Technical Information

154/22_{ENU} WNL4

WNL4 - Replacing Front Bumper (Workshop Campaign)

Revision: This bulletin replaces bulletin Group 6 154/22 WNL4, dated January 13, 2023.

Installation position

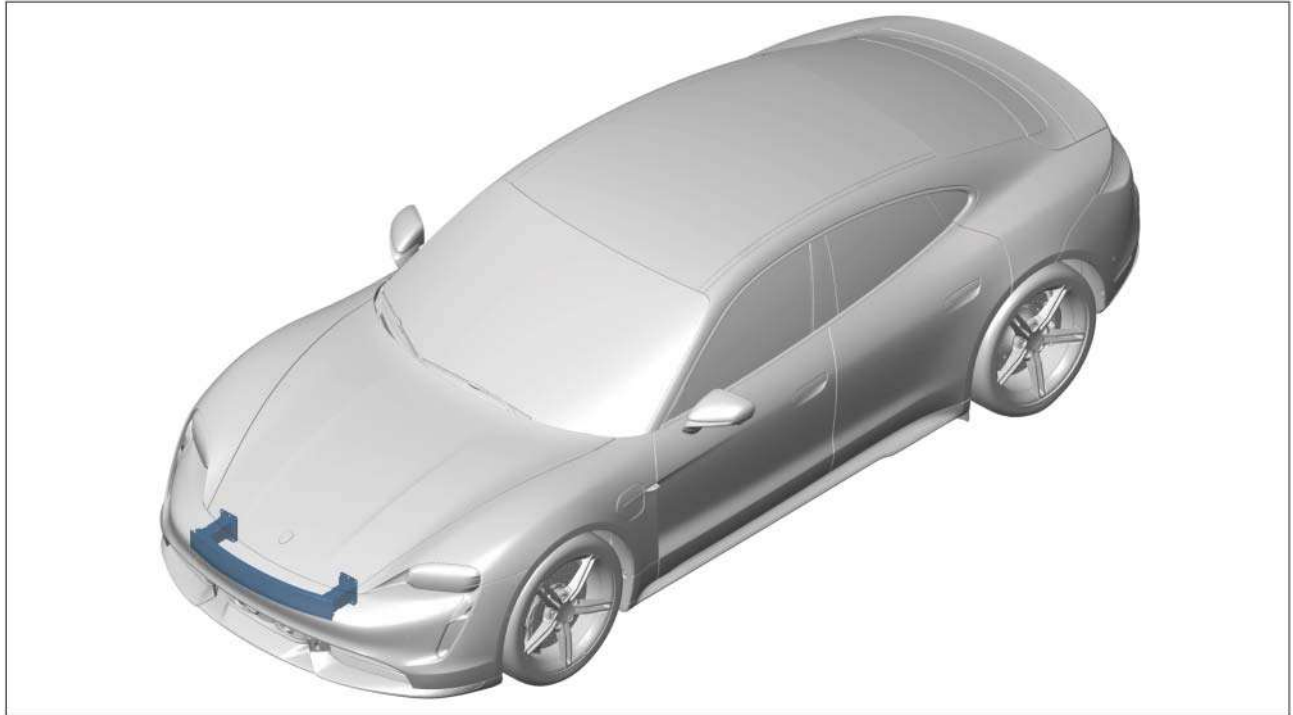
Cause: **There is a possibility on the affected vehicles that a welding joint on the bumper does not meet the required specifications.**

Action required: For this reason, the front bumper on the affected vehicles must be replaced with a bumper on which the welding joints meet the required specifications.

Installing driver assistance systems holder

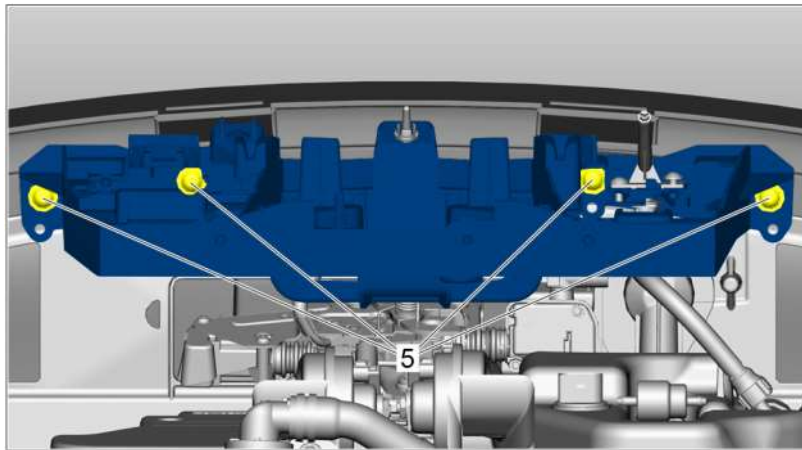
- Work Procedure: 1 Remove front bumper. ⇒ *Workshop Manual '631019 Removing and installing front bumper'*
- 2 Convert driver assistance systems holder to suit the **new** front bumper.
- 2.1 Loosen screws ⇒ *Installing driver assistance systems holder -5-* and remove the driver assistance systems holder.
- 2.2 Position driver assistance systems holder on the **new** front bumper.
- 2.3 Screw in and tighten screws ⇒ *Installing driver assistance systems holder -5-*. **Tightening torque 8 Nm (5.9 ftlb.)**
